ADDENDUM NUMBER 1

MILWAUKEE COUNTY ZOOLOGICAL GARDENS  
GREAT APES BUILDING MECHANICAL ROOM  
ROOF REPLACEMENT  
Site #355, Bldg. #4410  
10001 West Blue Mound Road  
Milwaukee, WI 53226

Project Number: Z115-13651

Date of Addendum: August 13, 2014

Sheet A1 – Note 2-B – DEMOLITIONS: Add the following statement: -

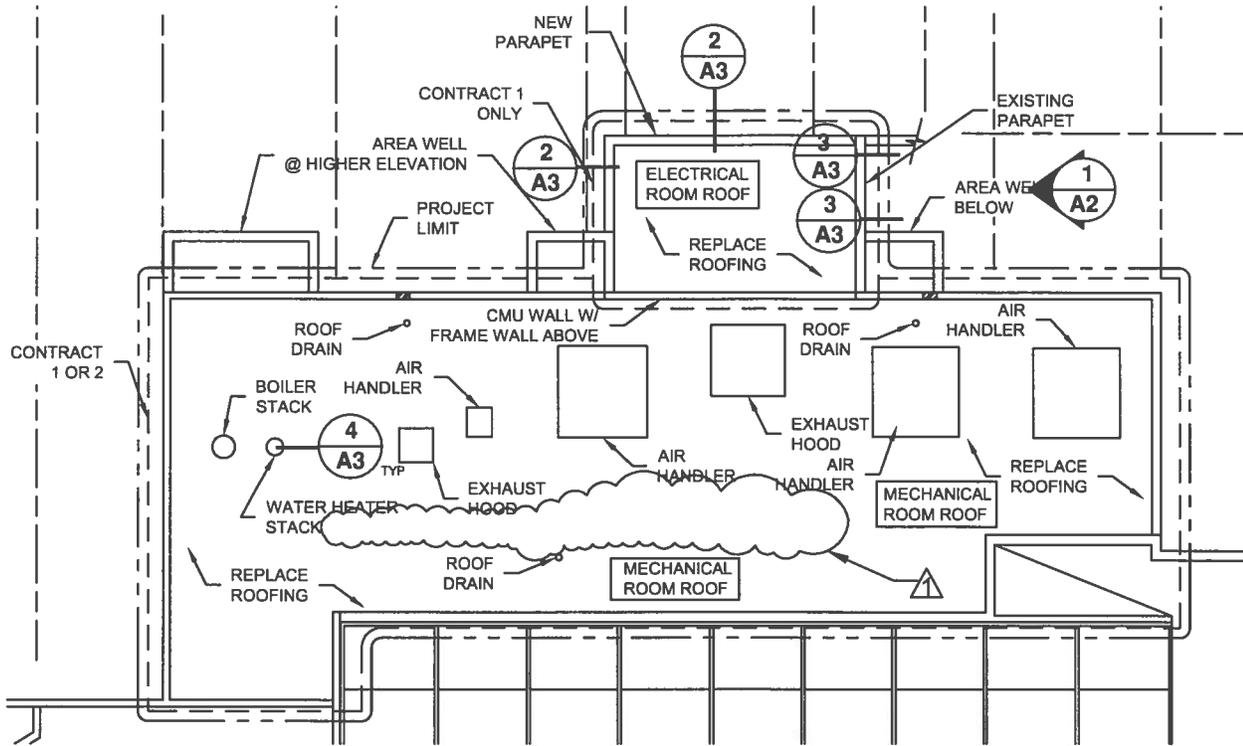
REMOVE EAST-WEST ROOF CURB BETWEEN THE TWO PORTIONS OF MECHANICAL ROOM ROOF, INCLUDING ALL MASONRY MATERIAL.

### ROOF REPLACEMENT PLAN

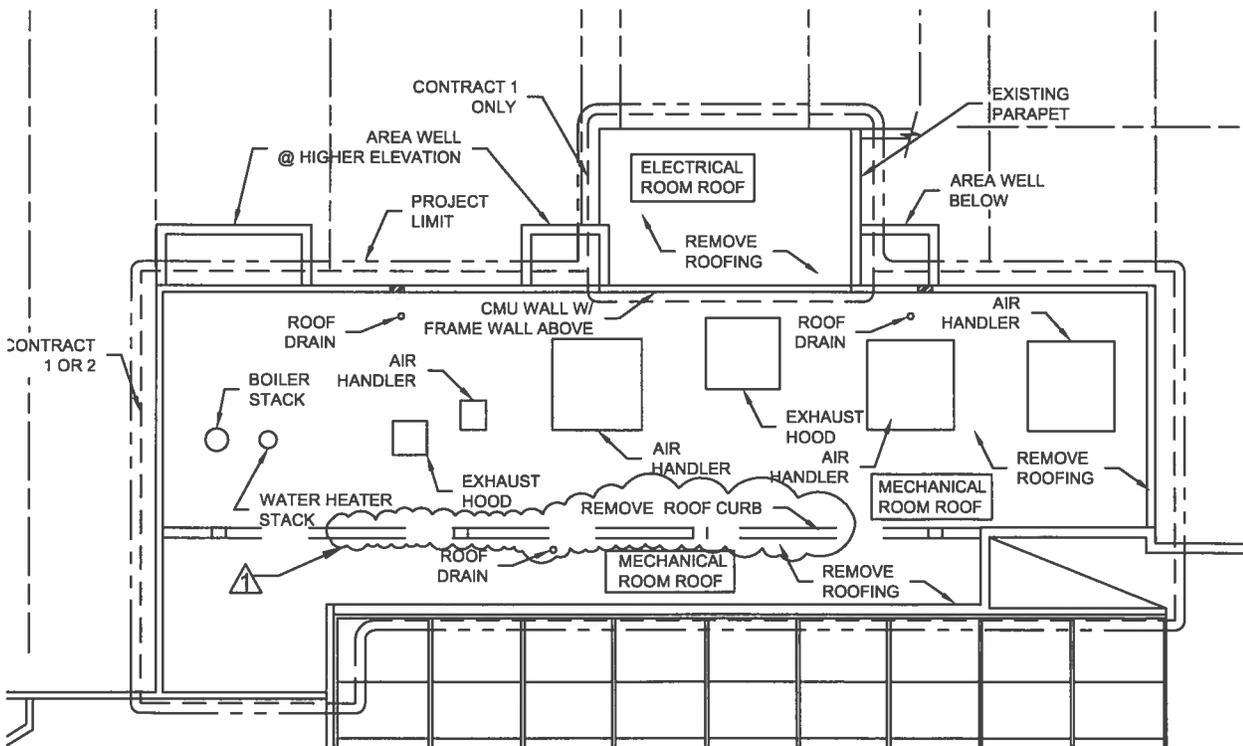
Roof Demolition Plan: Remove roof curb as indicated in new note shown in ROOF DEMOLITION PLAN included in SK01 attached to this addendum.

Roof Replacement Plan: Delete roof curb as indicated and shown in ROOF REPLACEMENT PLAN included in SK01 attached to this addendum.
